Coopersburg – East Station Ave. Streetscape Improvement Questions and Answers February 2020

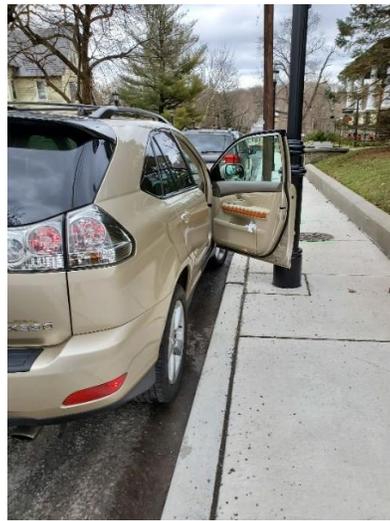
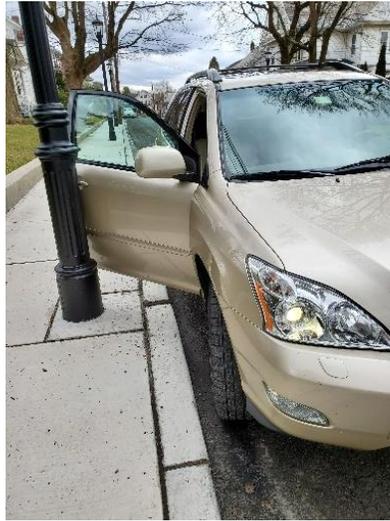
Question 6: Will the parking space designations on East Station Ave. make it difficult for car door opening at new Pedestrian Light poles and old Utility Poles?

Answer 6: The new Pedestrian light poles are 18" from curb, so they do NOT block passenger side car door, even if next to door (see photos below).

The parking space designations will be 25' long, while the average car length is 18'+/- which should provide enough room to park where the passenger door(s) can open without interference with the utility pole.
